LOUISVILLE – SOUTHERN INDIANA OHIO RIVER BRIDGES PROJECT

Indiana Historic Preservation Advisory Team (IHPAT)/Kentucky Historic Preservation Advisory Team (KHPAT) Meeting June 19, 2008 – 11:00 AM at the INDOT Falls City Sub-District

Downtown Bridge (SDC 2) Aesthetics and Recommendations for Approval

Value Engineering Tower Section

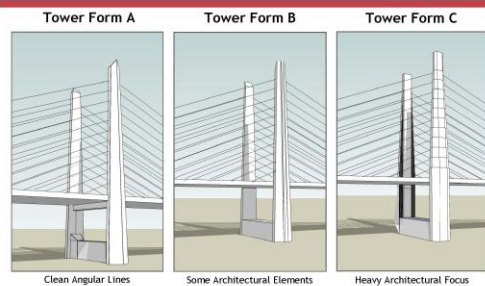
Shape of tower with triangular edge requires custom forming full height; simplify tower cross section.

The tower shape proposed by the VE is decoration and looks cheap.

The VE tower shape presented is not a simple spire shape tower characteristic of the historic context of the area. The VE tower is more complex in shape and character, which does not fit the historic context.

VE recommended tower section reduces forming cost (Saves Approximately \$10 Million)

SDC2 recommended tower section found to be aesthetically pleasing by HPATs

Support was offered for retention of the SDC 2 recommended tower section. It was noted that other tower shapes had been viewed and discussed at prior workshops.
